PZ&B Staff Combination Memorandum: Landmarks Preservation Commission and Town Council

SUBJECT: COA-23-038 (ZON-23-106) 318 AUSTRALIAN AVE.

MEETING: NOVEMBER 17, 2023 LPC
DECEMBER 13, 2023 TC

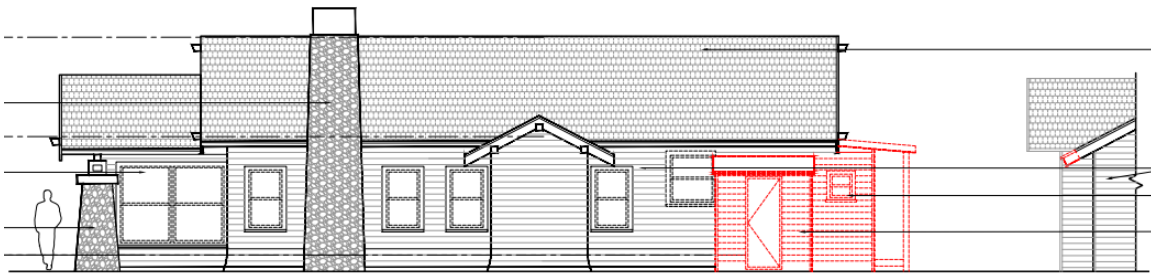
The applicant has included demolition floor plans, roof plans, and elevations on Sheets A-001 – A-008 of the architectural plan sets. In addition to the removal of windows, doors, and roof cladding, the application requests to demolish a rear enclosed porch and attached storage shed located on the west side of the property. Per the documentation provided, the request does not propose to demolish more than 50% of any elevation or roof structure. The application requests to replace the rear enclosed porch with a new enclosed breakfast room, which will be connected to the guest house with a new pergola structure. Existing and proposed West Elevations (Sheet A-006) are provided below and identify the areas of demolition in red and the proposed enclosed addition and pergola connector.

Areas to be Demolished in Red

New Enclosed Addition and Pergola
